1. Type of Well ✓ Oil Well Gas W	/ell Other		8. Well Name and No	O. TWEETY BIRD 8 FED COM/503H			
2. Name of Operator EOG RESOURC	CES INCORPORATED		9. API Well No.	30-025-51769			
3a. Address 1111 BAGBY SKY LOB		(include area code)	10. Field and Pool or CRUZ/BONE SPF

3. Describe Proposed or Completed Operation: Clearly state all pertinent details, including estimated starting date of any proposed work and approximate duration thereof. If the proposal is to deepen directionally or recomplete horizontally, give subsurface locations and measured and true vertical depths of all pertinent markers and zones. Attach the Bond under which the work will be perfonned or provide the Bond No. on file with BLM/BIA. Required subsequent reports must be filed within 30 days following completion of the involved operations. If the operation results in a multiple completion or recompletion in a new interval, a Form 3160-4 must be filed once testing has been completed. Final Abandonment Notices must be filed only after all requirements, including reclamation, have been completed and the operator has detennined that the site is ready for final inspection.) Tweety Bird 8 Fed Com 306H (FKA 503H) API #: 3

Revised Wellbore A:

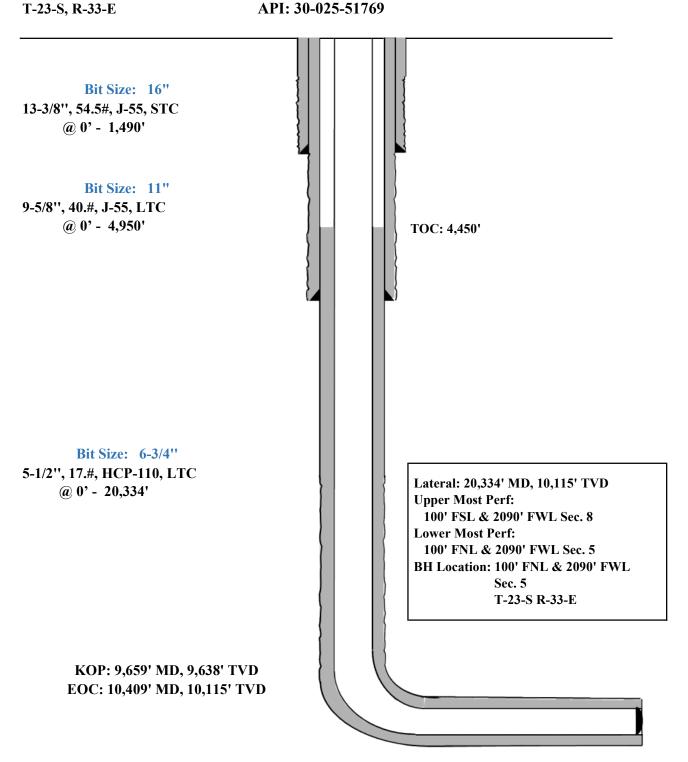
Casing Program A:

Hole	Interv	al MD	Interva	al TVD	Csg			
Size	From (ft)	To (ft)	From (ft)	To (ft)	OD	Weight	Grade	Conn
16"	0	1,490	0	1,490	13-3/8"	54.5#	J-55	STC
11"	0	4,976	0	4,950	9-5/8"	40#	J-55	LTC
6-3/4"	0	20,334	0	10,115	5-1/2"	17#	HCP-110	LTC

Variance is requested to waive the centralizer requirements for the 9-5/8" casing in the 11" hole size. An expansion additive will be utilized, in the cement slurry, for the entire length of the 11" hole interval to maximize cement bond and zonal isolation.

Variance is also requested to waive any centralizer requirements for the 5-1/2" casing in the 6-3/4" hole size. An expansion additive will be utilized, in the cement slurry, for the entire length of the 6-3/4" hole interval to maximize cement bond and zonal isolation.

EOG requests permission to allow deviation from the 0.422" annulus clearance requirement for the intermediate (salt) section from Onshore Order #2 under the following conditions:

Design A

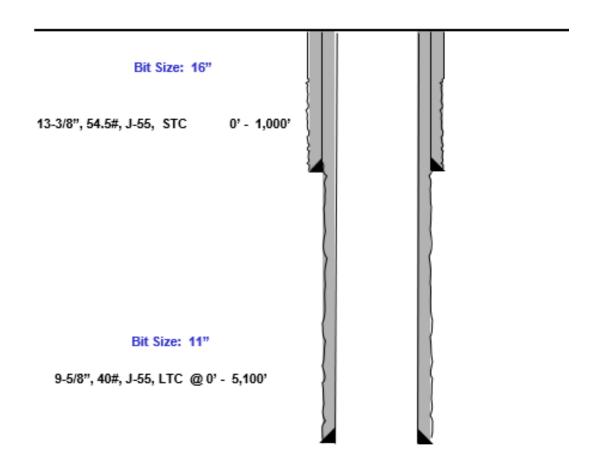
Proposed 11" Hole with 9.625" 40# J55/HCK55 LTC Casing

- 11" Bit + 0.52" Average hole enlargement = 11.52" Hole Size
 - 0.9475" Clearance to casing OD

• 0.4475" Clearance to coupling OD

Proposed 9.875" Hole with 8.625" 32# J55/P110 BTC-SC Casing

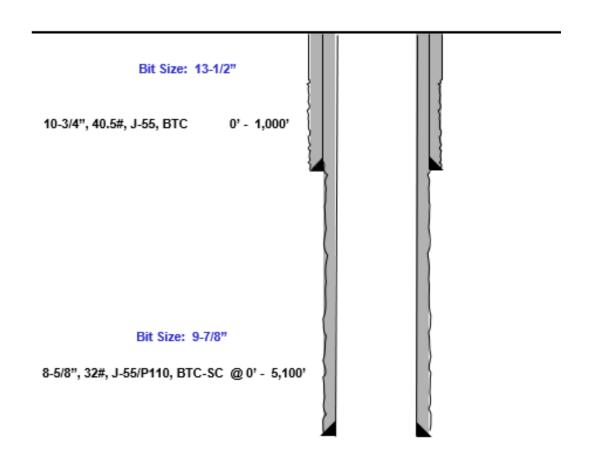
- 9.875" Bit + 0.42" Average hole enlargement = 10.295" Hole Size
 - 0.835" Clearance to casing OD

• 0.585" Clearance to coupling OD
